## **FRANKLIN PRIMARY HEALTH CENTER**

### **CODY ROAD SUBDIVISION**

Engineering Comments: FINAL PLAT COMMENTS (should be addressed prior to submitting the FINAL PLAT for review and/or signature by the City Engineer):

# DETAIL SITE PLAN

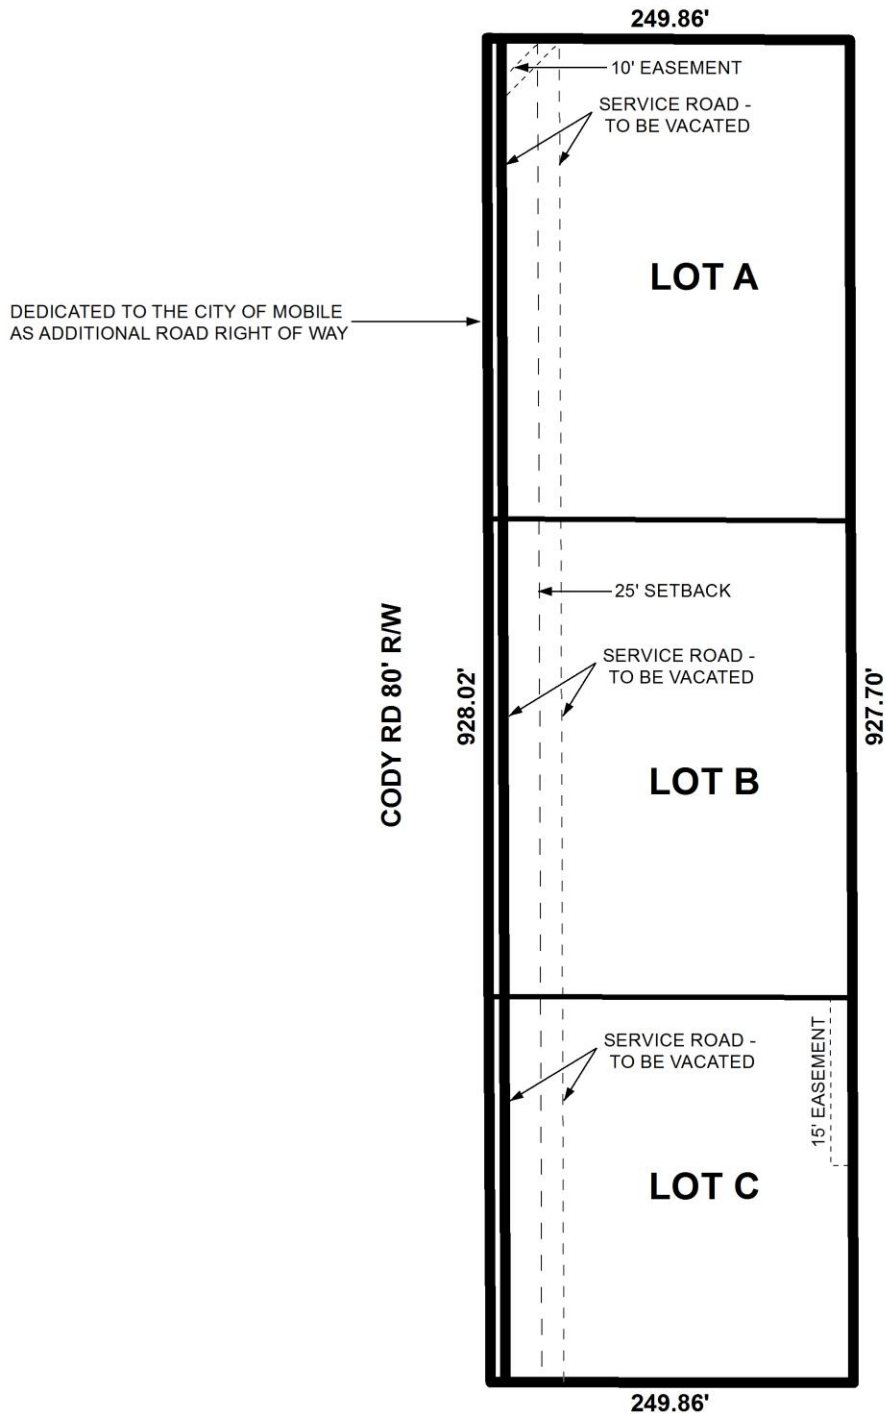
The proposed lots front Cody Road, a major street on the Major Street Plan. As a major street, Cody Road requires a 100' right-of-way width. The preliminary plat illustrates an 80' right-of-way width. Parcels 2B, 3B, and 4B, located between Cody Road and lots A, B and C, include a note stating "hereby dedicated to the City of Mobile as additional road right-of-way". The parcels would add an additional 10' of right-of-way and would result in sufficient dedication from the centerline of Cody Road. If approved, right-of-way width should be retained on the Final Plat. The preliminary plat also illustrates a service road to be vacated with a 40' right-of-way width.

A 25-foot minimum building setback line is depicted on the preliminary plat along Cody Road for the proposed Lots A, B, and C. If approved, the 25' setback along Cody Road should be retained on the Final Plat. The setback should also be depicted where Portsmouth Drive stubs into Lot C.

The preliminary plat illustrates a 15' private drainage easement on Lot C and a 10' sidewalk easement on Lot A.

The proposed Lots A, B, and C all exceed the 7,200 square foot minimum lot size requirements for lots served by public water and sanitary sewer systems. The preliminary plat provides the lot sizes in both square feet and acres and if approved, the lot size information should be retained in both square feet and acres on the Final Plat.

As a means of access management, a note should be placed on the Final Plat, if approved, stating that Lot A and Lot B are limited to two curb cuts each. Lot C is limited to one curb cut to Cody Road and denied access to Portsmouth Drive. Driveway size, location and design to be approved by Traffic Engineering and conform to AASHTO standards.

- 1) Retention of the 25' minimum building setback line along Cody Road and where Portsmouth Drive stubs into Lot C;
- 2) Retention of the right-of-way width for Cody Road, including the depiction of right-of-way dedication;

- 3) Retention of lot size information in both square feet and acres;
- 4) Placement of a note on the Final Plat stating that Lot A and Lot B are limited to two curb cuts each. Lot C is limited to one curb cut to Cody Road and denied access to Portsmouth Drive. Driveway size, location and design to be approved by Traffic Engineering and conform to AASHTO standards. Any on-site parking, including ADA handicap spaces, shall meet the minimum standards as defined in Section 64-6 of the City's Zoning Ordinance.
